## Technical Service BULLETIN

### HIGH BEAM INDICATOR LIGHT INOPERATIVE

'01 Sequoia

EL007-01

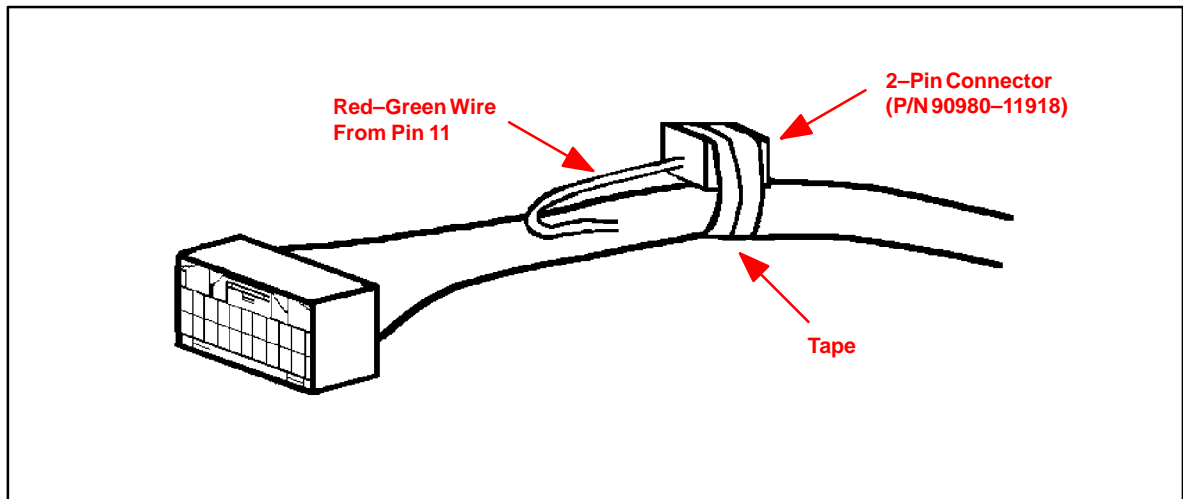
1. Modify the high beam indicator circuit wiring.
  - A. Remove the Combination Meter. See page BO–88 in the 2001 Sequoia Repair Manual.
  - B. Locate connector C7 at the back of the combination meter.
  - C. Remove pin 11 (red and green wire) from the back of the connector.

- D. To protect the terminal end, insert Pin 11 into the 2-pin connector (P/N 90980–11918) and verify pin tightness.
    - E. Tape the connector to the harness as shown below.
